**TOWN OF MOUNTAIN VILLAGE
DESIGN REVIEW BOARD REGULAR MEETING
THURSDAY MARCH 30, 2017 10:00 AM
2nd FLOOR CONFERENCE ROOM, MOUNTAIN VILLAGE TOWN HALL
455 MOUNTAIN VILLAGE BLVD, MOUNTAIN VILLAGE, COLORADO**

REVISED AGENDA

Application Overview: The purpose of this agenda item is to allow the Design Review Board (DRB) to provide initial direction to the applicant regarding a proposed new single family home.

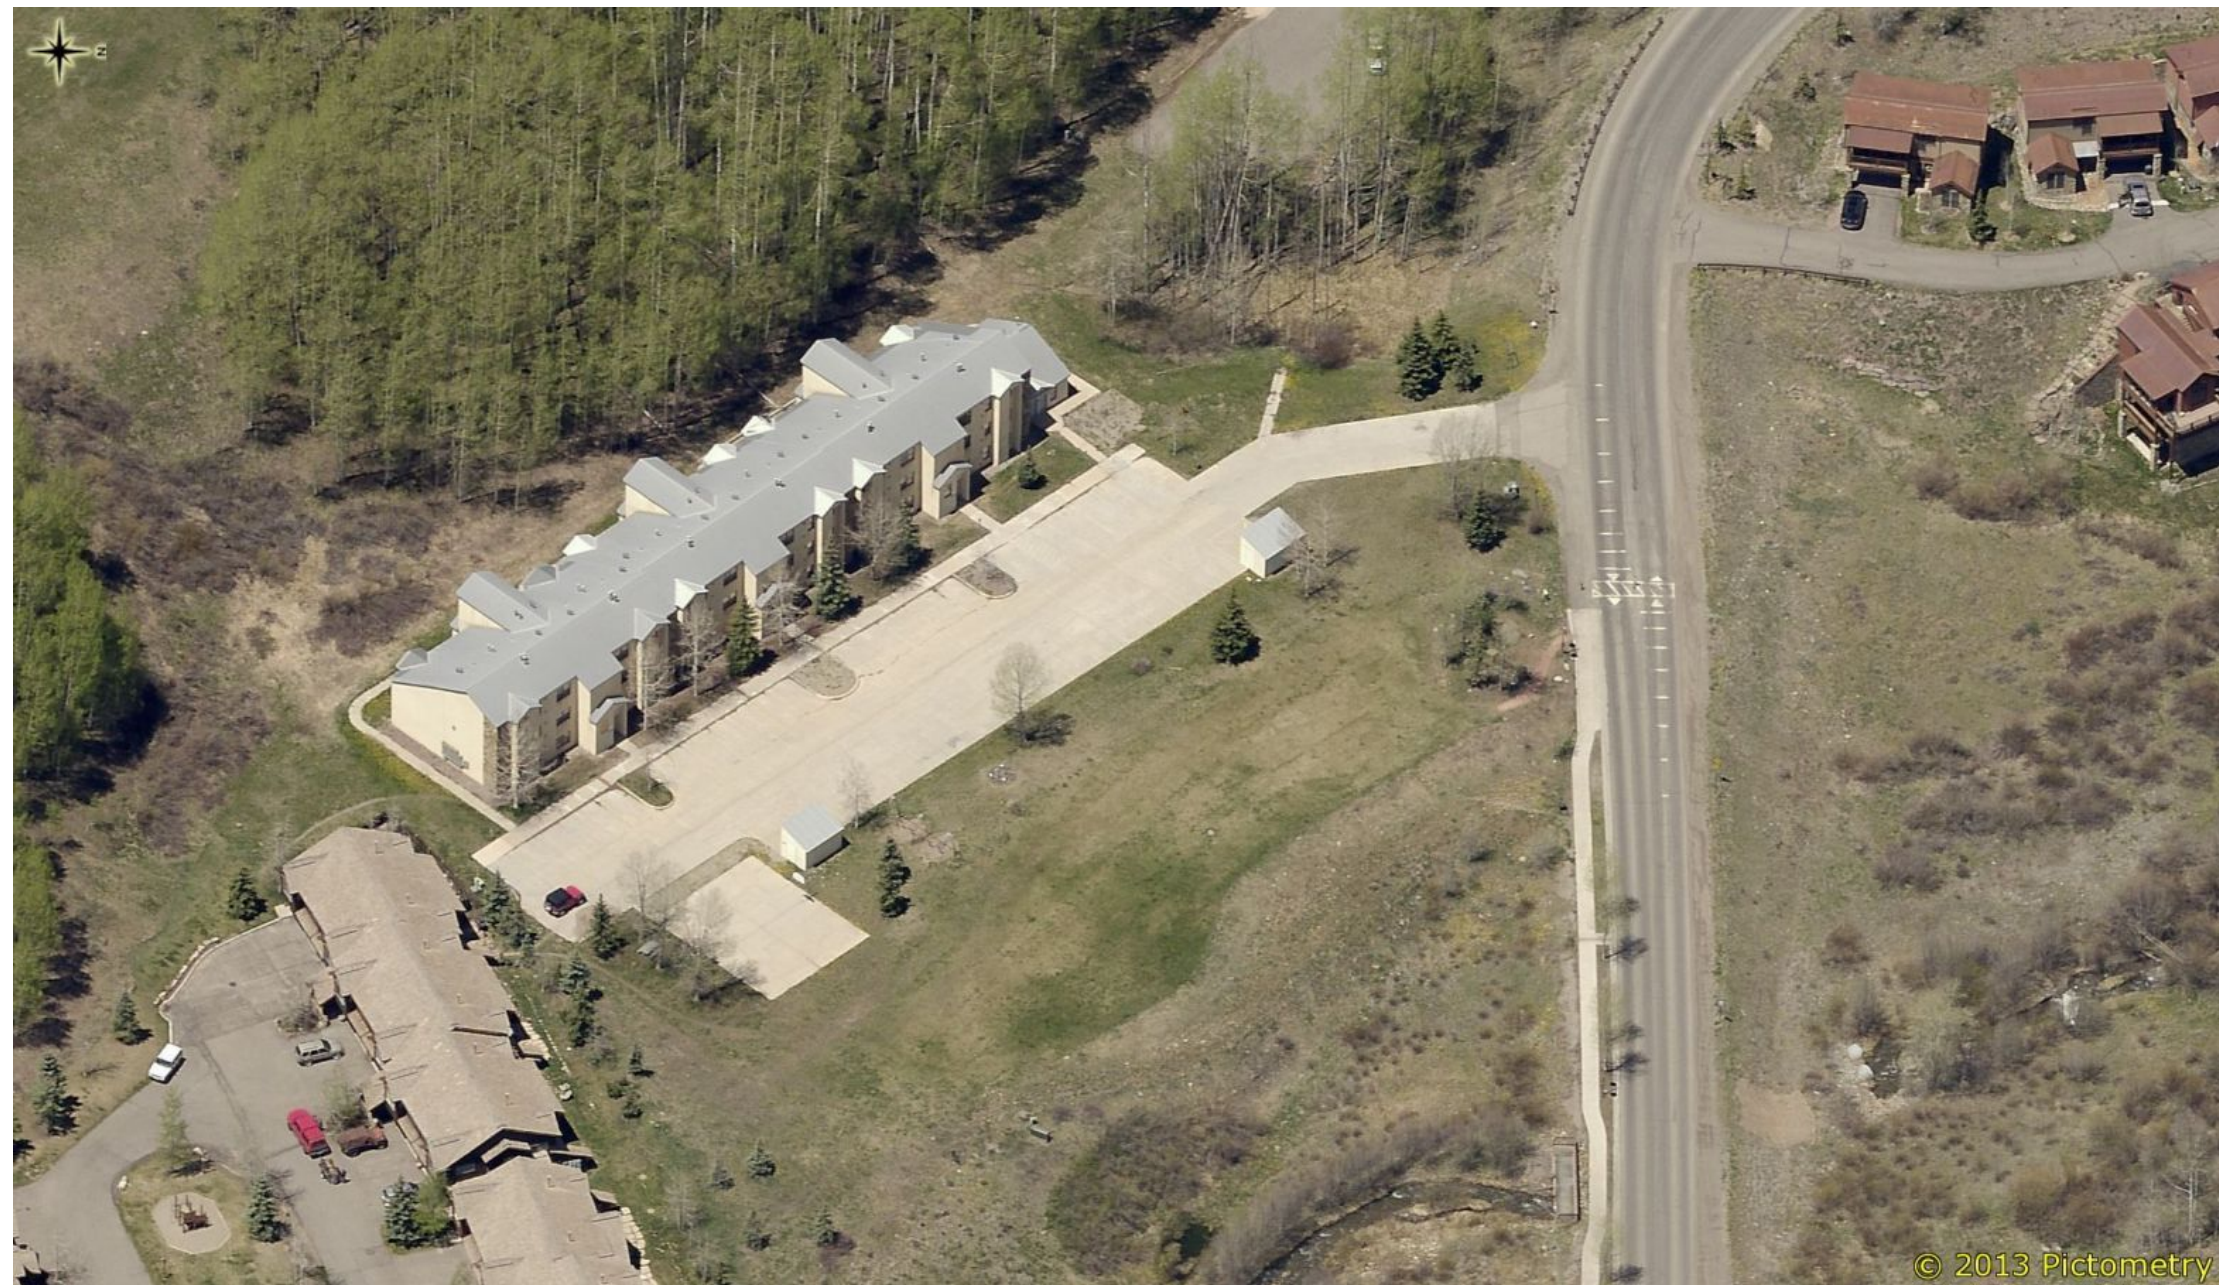
Staff believes the proposed changes are a vast upgrade from the current dated façade. The variety of exterior materials breaks up the elevations in a way that makes sense and protects the exterior from snow. The addition to the roof overhangs will protect the exterior elevations and throw shadows on the walls. The proposed upgrades go a long way in masking the project's purpose of providing affordable work force housing and integrate the project into The Meadows. Staff suggests the following additional considerations:

- Consider reducing the stone on Scheme 2 to below the second floor gable ends at the main entry to bring the scale of the entry to a pedestrian level;
- Review new proposed exterior lighting to replace current out of compliance wall packs. Denote entrances with an architectural fixture;
- Provide specimen tree in each parking lot islands;
- Provide a stone entry monument adjacent to Adams Ranch Road;
- Upgrade the front doors.
